Access Compliance Report

Public Rights-of-Way

(Curb Ramps)

Intersection ID: 52448	Main Street: WOODWARD_AV	Cross Street: DOUBLE_OAKS_RD	Location: NE
ADA ID: 4123EBB14977	Ramp Type: Directional1	Initial Pass/Fail: Pass	Overall Compliance: No
Severity Score: 15.25			
Codes/Mitigation Info/Possible Solution		Field Measurements/Component Compliance

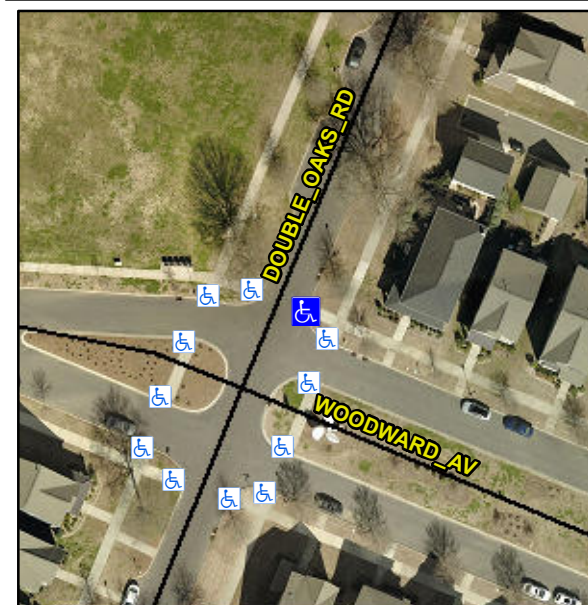
R304.5.3, R305.2, R302.7.2

Compliance	Description	Data	Compliance	Description	Data
N/A	Ramp Length (in)	66.0	Yes	Grade Break?	Yes
Yes	Ramp Width (in)	67.0	Yes	Grade Break Slope (%)	1.2
Yes	Ramp Slope (%)	5.4	No	Grade Break XSlope (%)	4.0
Yes	Ramp XSlope (%)	2.7			
Yes	Flare Type LT	N/A	Yes	Flare Type RT	N/A
N/A	Flare Slope LT (%)	N/A	N/A	Flare Slope RT (%)	N/A
N/A	Flare Traversable LT?	No	N/A	Flare Traversable RT?	No
Yes	Landing Length (in)	95.0	Yes	DWS Provided?	Yes
Yes	Landing Width (in)	76.0	Yes	DWS Contrast?	Yes
Yes	Landing Slope (%)	0.5	Yes	DWS Length (in)	24.0
Yes	Landing X Slope (%)	2.3	Yes	DWS Full Width?	Yes
N/A	Landing Curb? (Y/N)	N/A	Yes	DWS Offset LT (in)	17.0
N/A	Shared Landing?	No	No	DWS Offset RT (in)	2.5
Yes	Gutter Ponding?	No	Yes	Gutter Slope (%)	1.0
No	Gutter Lip Ht (in)	2.0	No	Gutter X Slope (%)	4.3
N/A	Painted X Walk1?	No		Road Slope (%)	3.5
	X Walk 1 Direction	To W		Road X Slope (%)	2.9
	X Walk 1 Width (in)	N/A		Clear Space?	Yes

**Remove & Replace Entire Ramp.
Remove & Replace Gutter.**
